**ADDENDUM NO. 4**

**SOUTHEAST TEXAS REGIONAL AIRPORT TERMINAL  
RENOVATION**

BID NO: 08-046/DC

**Bid Date: April 07, 2008; 11:00 AM**  
Addendum No. 4; **Issued April 2, 2008**

**EXHIBIT SHOWING BENCHMARK  
 SET "X" IN LIGHTPOLE BASE**

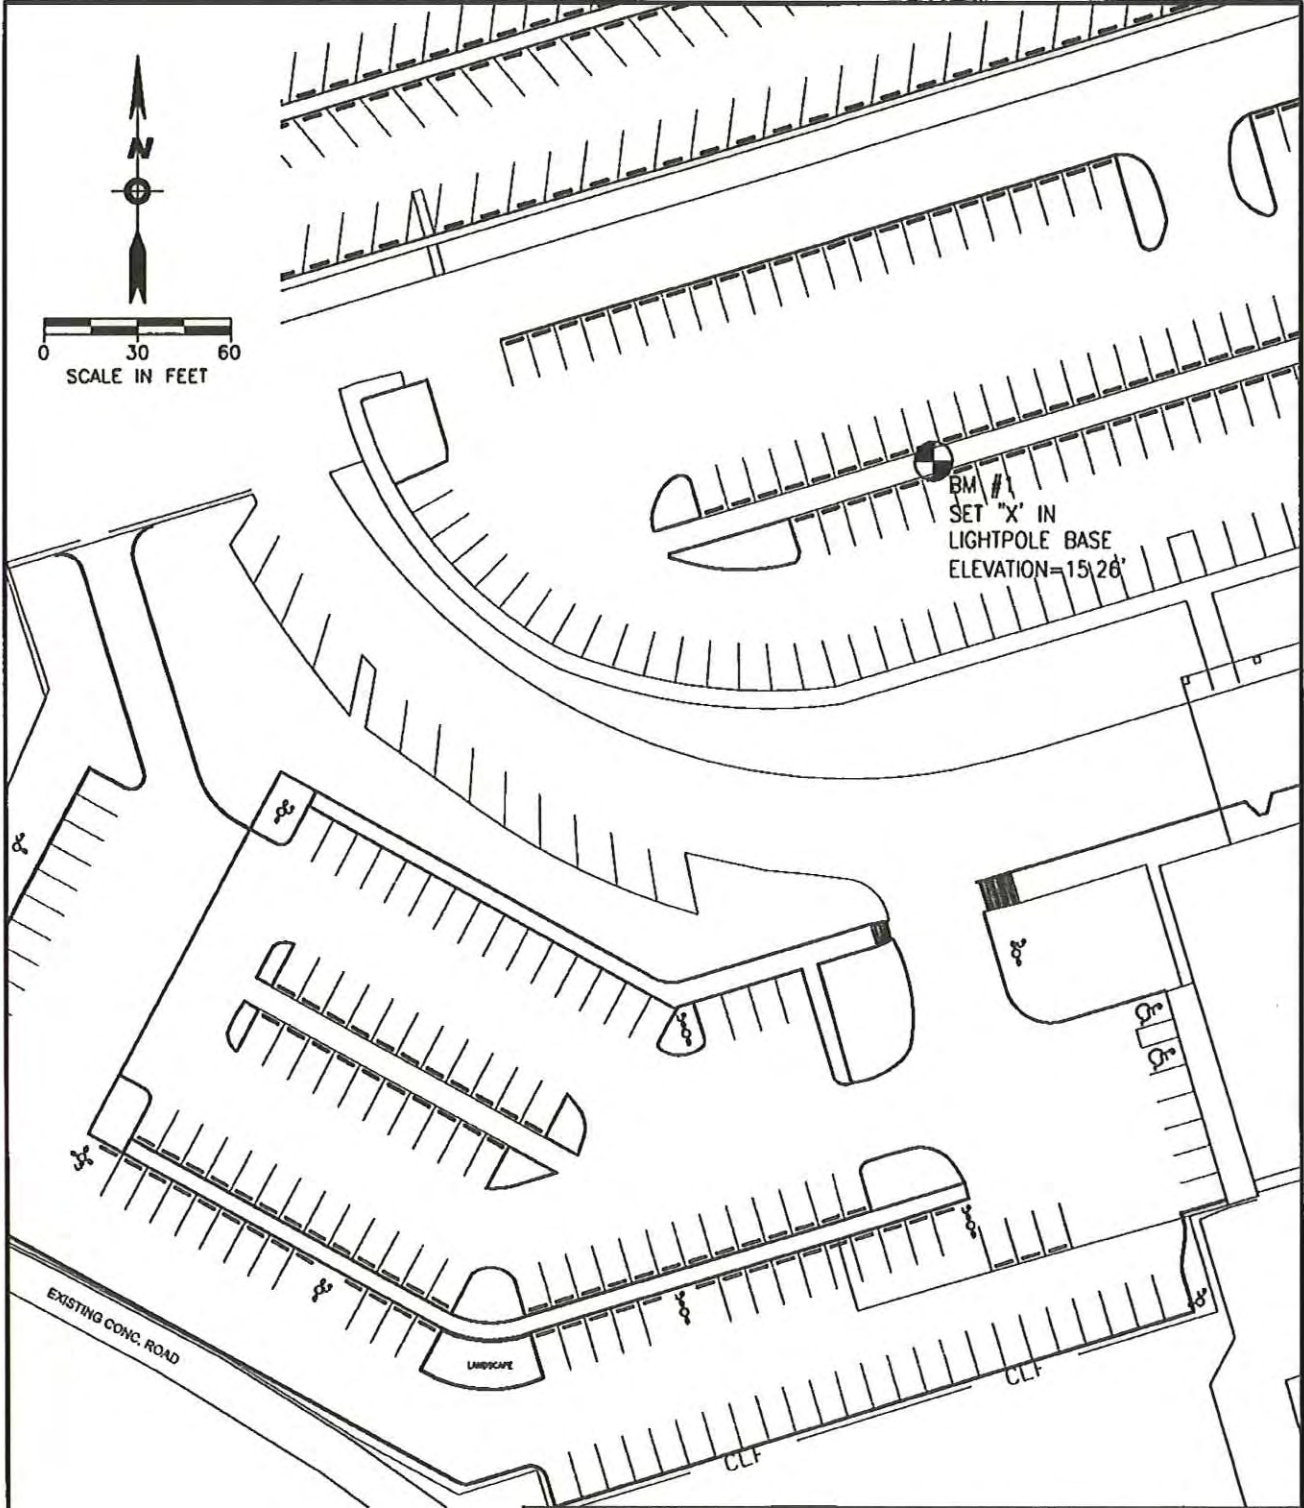
- 2.1 Reference the attached Exhibit Sketch for benchmark information relating to drawing C04-00 prepared by Arceneaux and Gates Consulting Engineers Inc.
- 2.2 Contractor to provide and warranty the items listed in the attached "Options and Accessories" schedule for the new chillers specified in Addendum No. 3.

BM #1  
 SET "X" IN  
 LIGHTPOLE BASE  
 ELEVATION=15.26'
